Prairie Island Nuclear Generating Plant Units 1 and 2
Dockets 50-282 and 50-306
License Nos. DPR-42 and DPR-60

Supplement to License Amendment Request (LAR) to Revise the Spent Fuel Pool Criticality Analyses and Technical Specifications (TS) 3.7.17, "Spent Fuel Pool Storage" and 4.3, "Fuel Storage" (TAC Nos. MC5811 and MC5812)

PRAIRIE ISLAND NUCLEAR GENERATING PLANT Response to Request for Additional Information

Figure 4.3.1-1

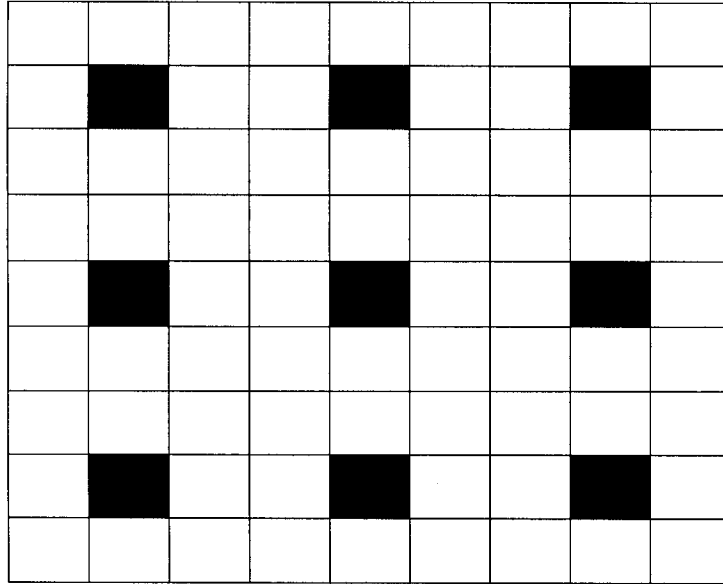
NMC's proposed TS Figure 4.3.1-1 allows the storage of fresh fuel assemblies in the spent fuel pool with or without gadolinium based on ensuring that adjacent spent fuel assemblies satisfy minimum burnup requirements. However, the licensee did not propose TS limits that will require a minimum gadolinium loading, in accordance with assumptions used in the criticality analyses, in the fresh fuel prior to placing it in the designated storage locations. Therefore, the staff requests that the licensee provide additional information demonstrating that sufficient controls will be put in place to ensure fresh fuel assemblies loaded in the spent fuel storage racks will be appropriately controlled based on the amount of gadolinium.

The legend for "Fresh Fuel" on proposed TS Figure 4.3.1-1 is revised to include minimum gadolinia (GAD) requirements. The revised figure is provided in Enclosures 2 and 3 of this supplement. With this change, the minimum required gadolinia loading in the fresh fuel is specified and will be controlled by NMC procedures which reference this Figure.

Assemblies with GAD shall have a minimum of 4 fuel rods with a minimum concentration of 4.0 w/o Gd₂O₃
